: SPR-1995-060

Project Name: Mini-storage

TITLE HEADING: Site Plan Review - Mini-storage  
Units

REVIEW COMMENTS FOR: SPR-95-60 Mini Storage Units

SU DESIGN VEHICLE

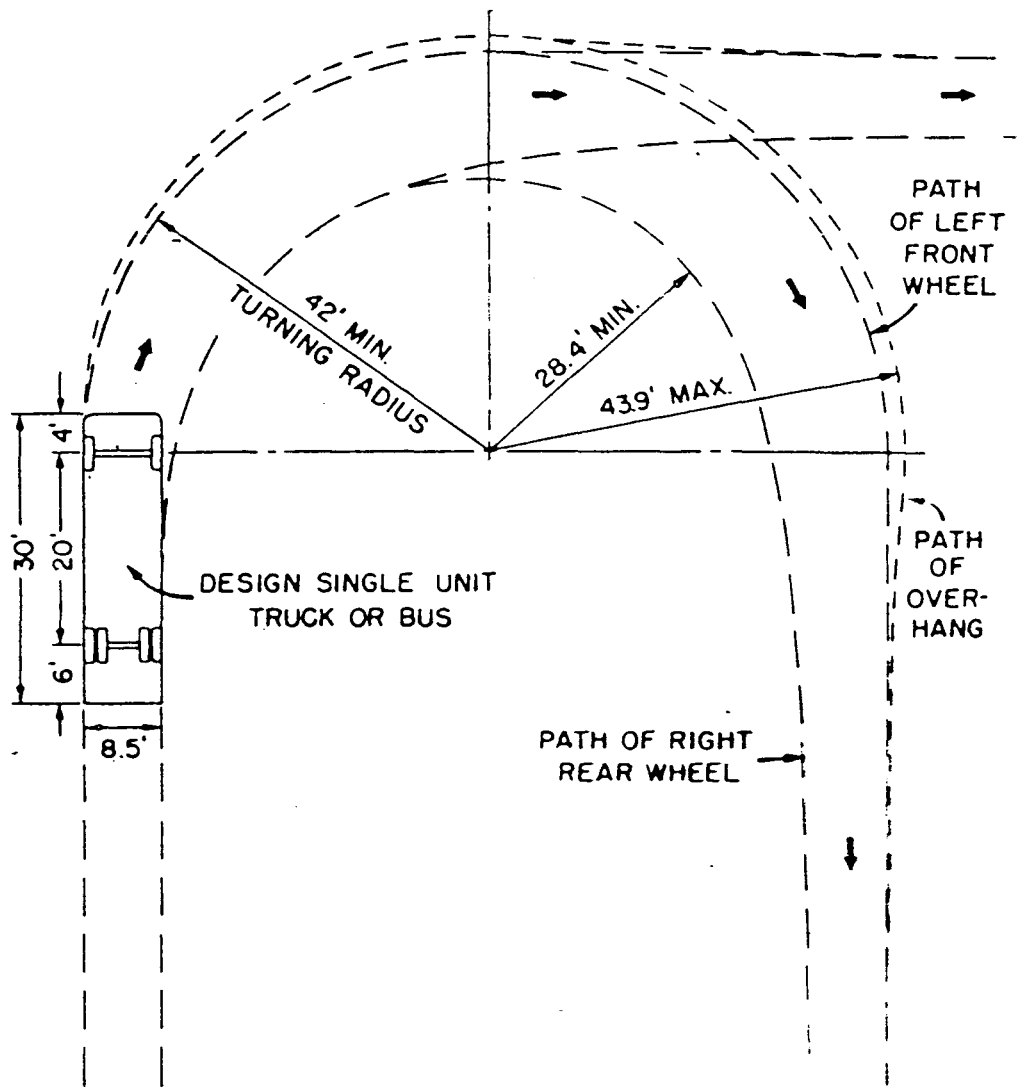
The placement of buildings on site look like there will be some difficulty with larger vehicles maneuvering on-site. I have included a copy of a turning template for a single unit vehicle for your use.

R.O. DETAINING AREA PLAN  
1/2" = 1'-0"

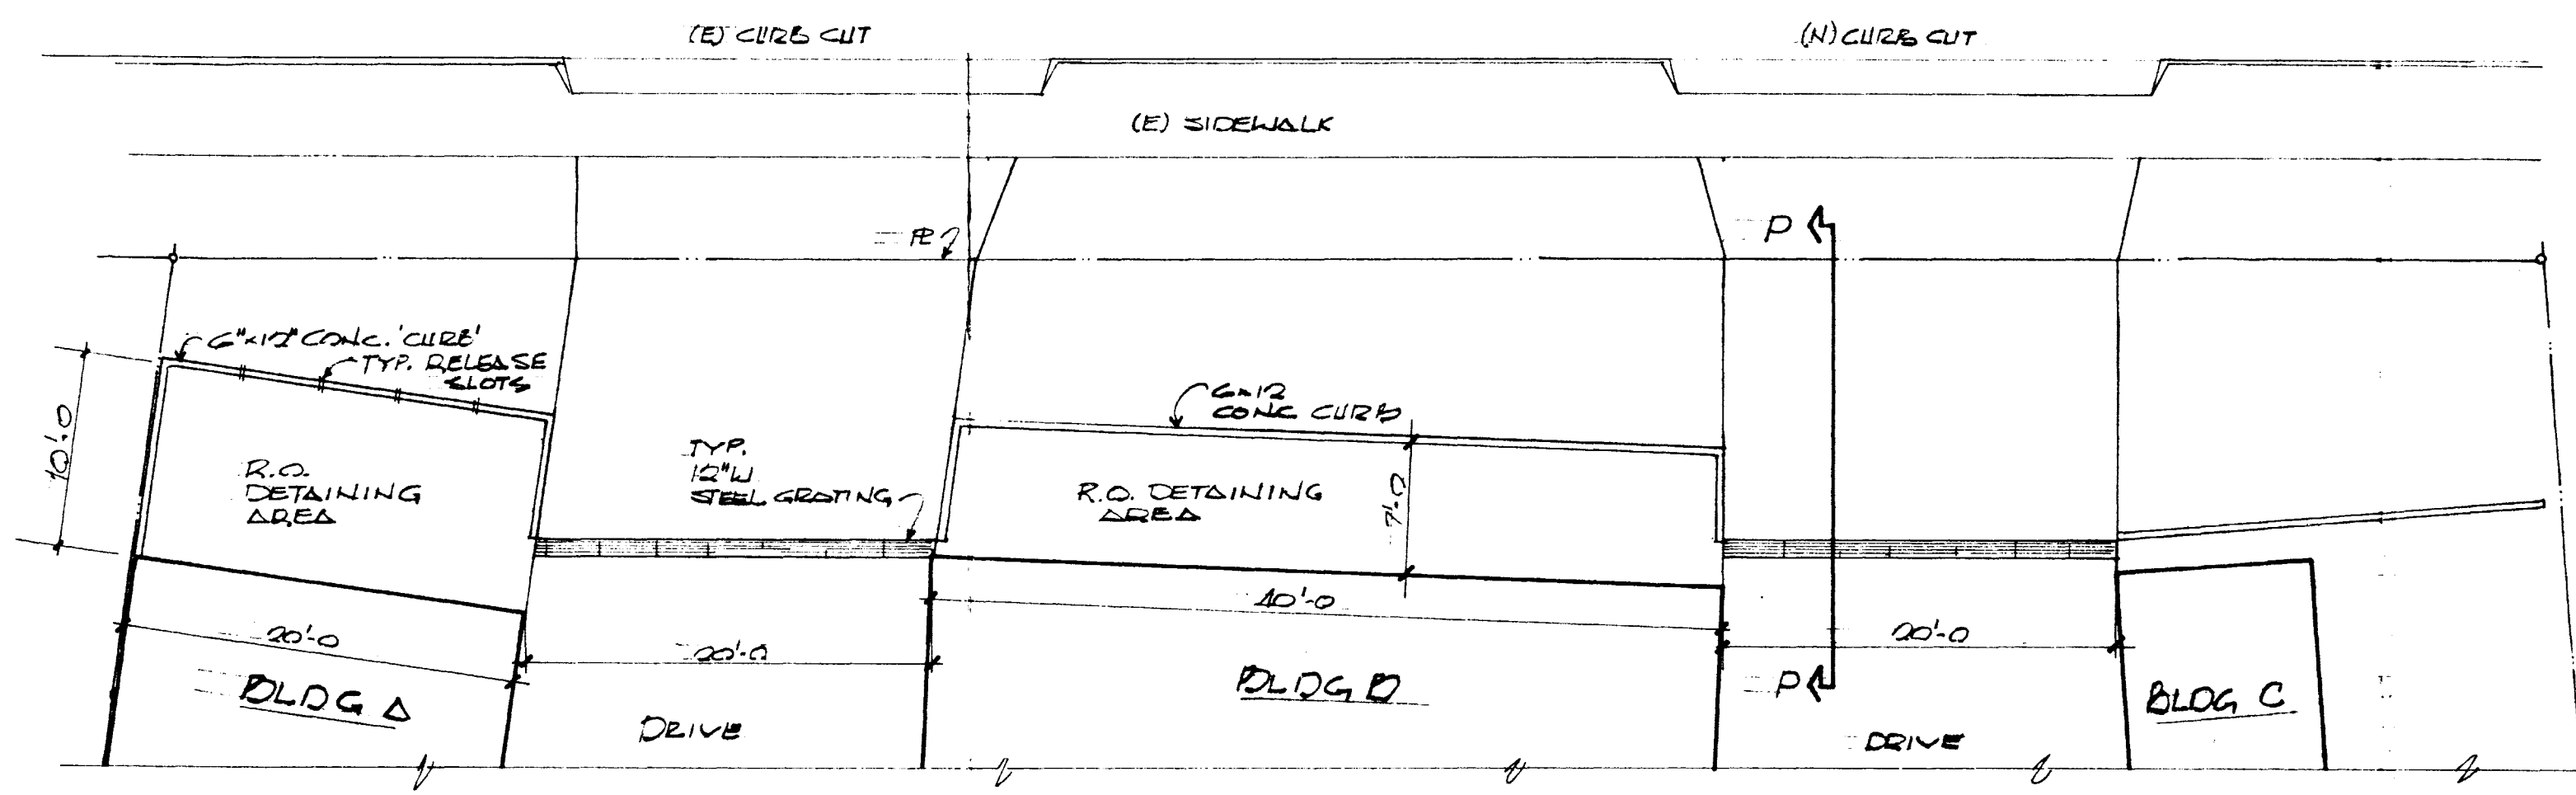
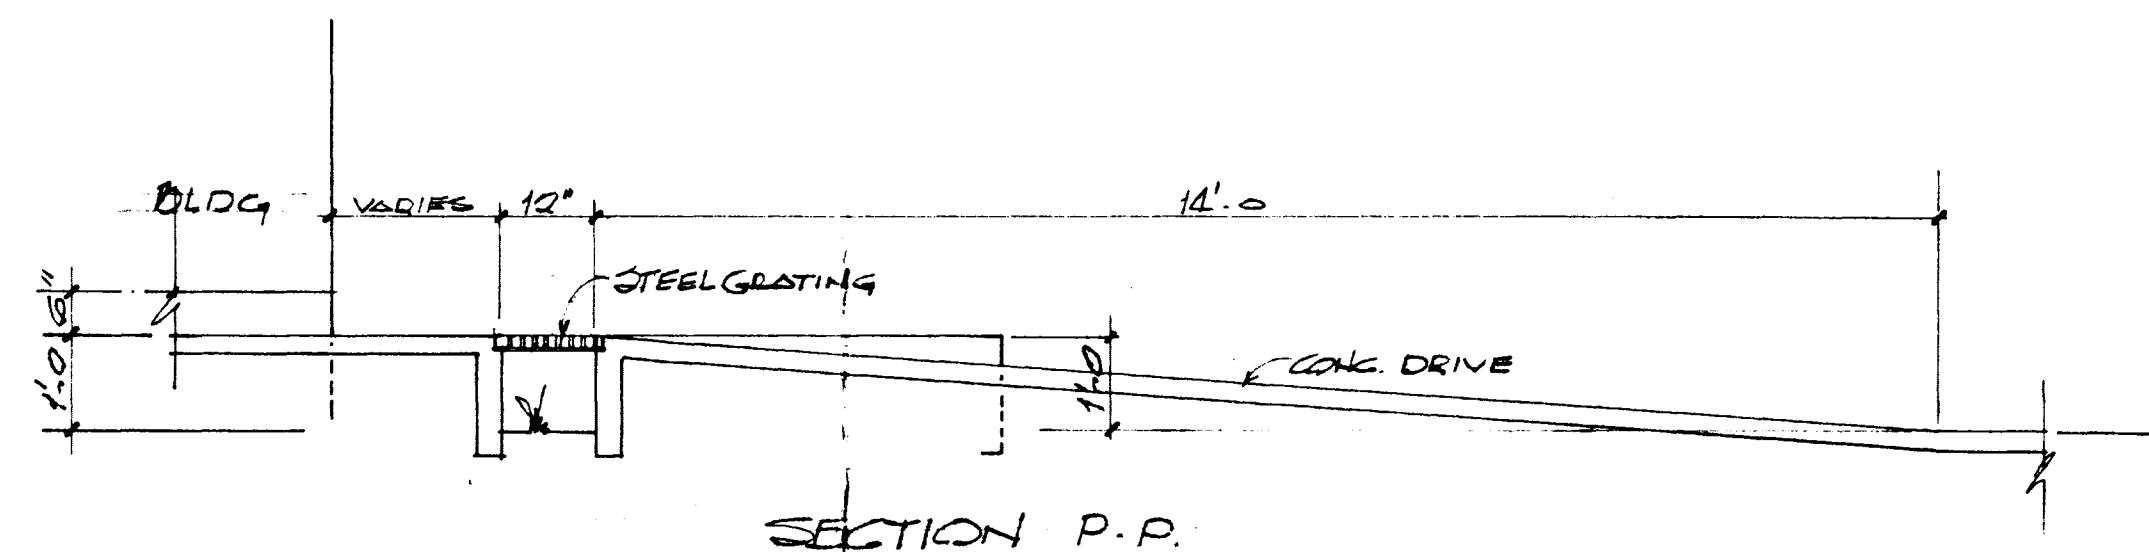
The plan needs to show a detail for the proposed outlet structure consistent with the revised drainage report.

1. It is not clear in the report how Qr was selected. Generally, it should be in keeping with Figure N-2 in the City SWMM Manual, consistent with the selected outlet structure design.
2. The calculations for the detention storage volume need to use the developed Qd. When I checked the calculations for the required 100 year storm storage, I came up with a substantially higher required volume. This means the landscaped area proposed as detention is not large enough, and part of the on-site paved area must be used for storage.
3. A volume-depth graphs or table should be developed to determine the maximum depth for the 2-year and 100-year storms and to design the outlet works. A sample drainage study for

GRADING, LANDSCAPING & SITE PLAN 1" = 20'-0"

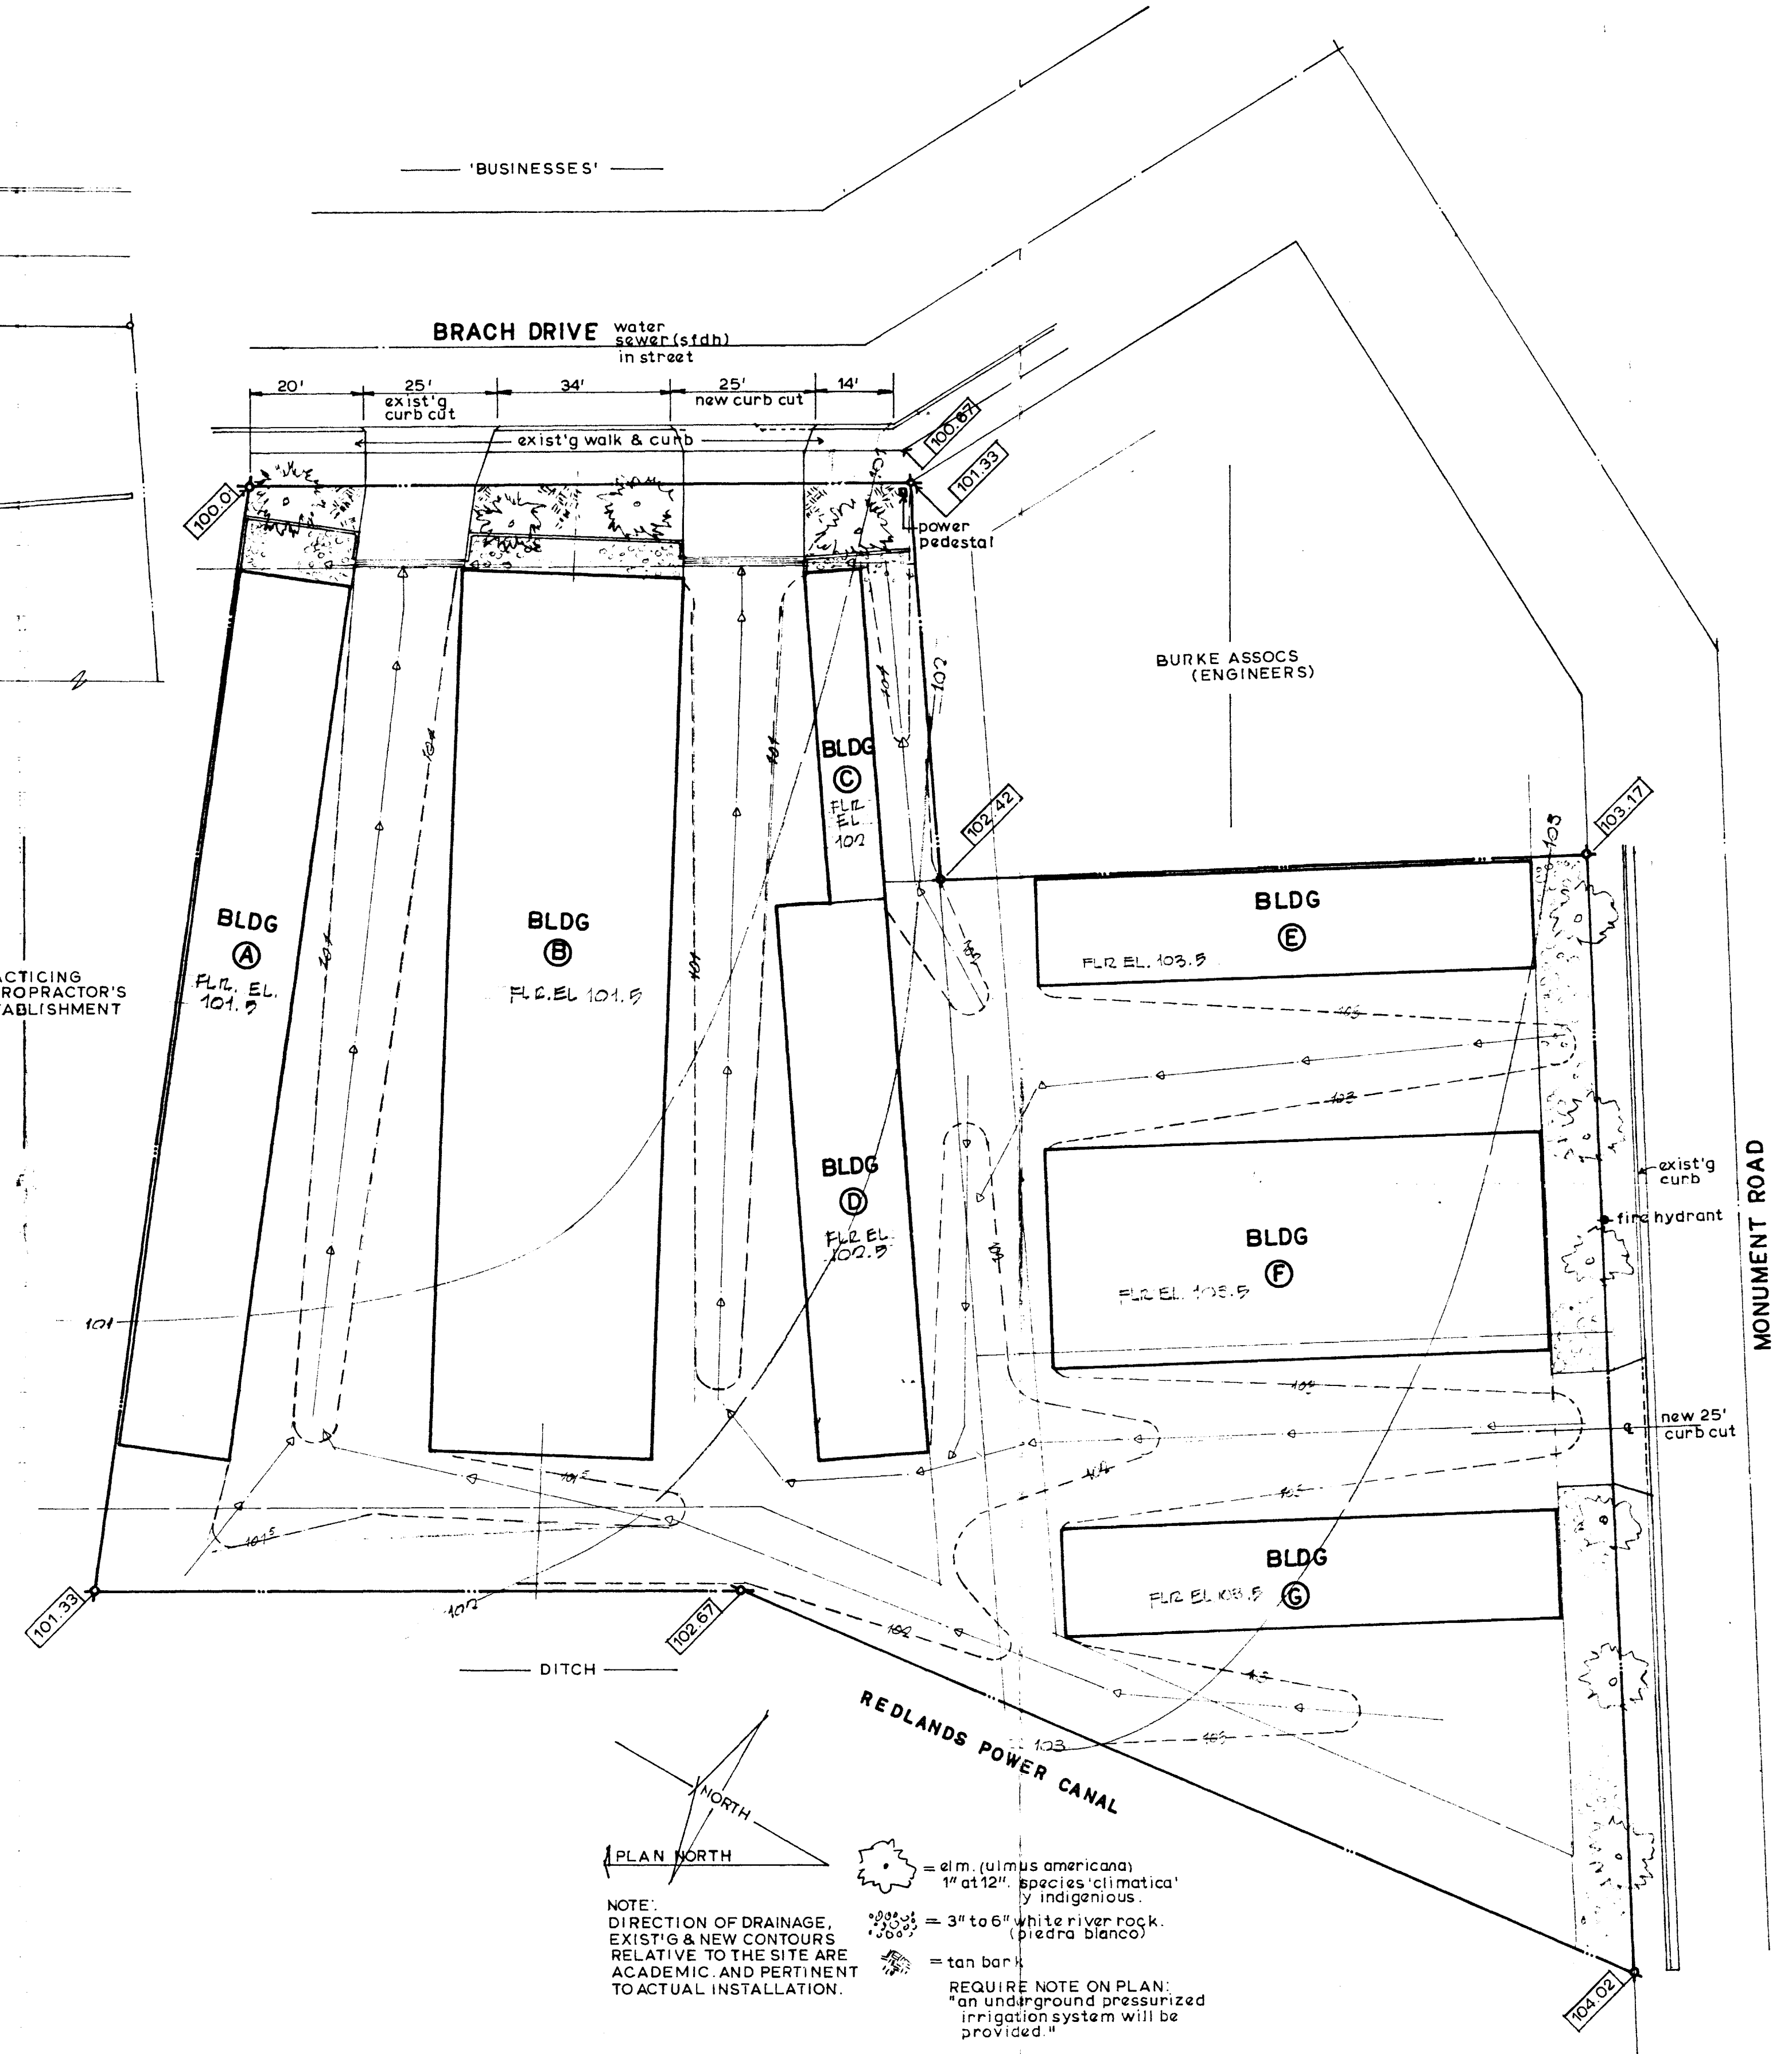
The limits of the paved area are not indicated on the site plan. If building C does not have doors on the northeast side, then not paving behind it would be preferable.

- OK 1. Landscaping Plan incomplete, see attached checklist for missing items.
- OK 2. Elm trees proposed do not meet minimum size standards; Section 5-4-15B(1) of the Zoning and Development Code requires a minimum of one and one-half inch (1 1/2") caliper (measured one foot above ground level) for all deciduous trees.

- Number of plants & location of shrubs on plan unclear*  
3) Minimum area required for landscaping provided, however, landscaping provided does not meet Code requirements as follows:

- OK 4. Eleven (11) trees are required as per Sections 5-4-15A and 5-4-15H while only ten (10) trees are provided.
- OK 5. The paving material to be used shall be indicated on the plans; all vehicular travel areas must be paved with asphalt or concrete, gravel is not permitted.

1. City Code requires that the area within the City right-of-way (not covered by sidewalk, driveways, etc) be landscaped. This must be clearly indicated on the Landscape Plan.
2. Number & location of shrubs on the plan is unclear; please revise to clarify.
3. Four sets of signed and sealed revised plans must be provided to Community Development which will be stamped and issued with the Planning Clearance.
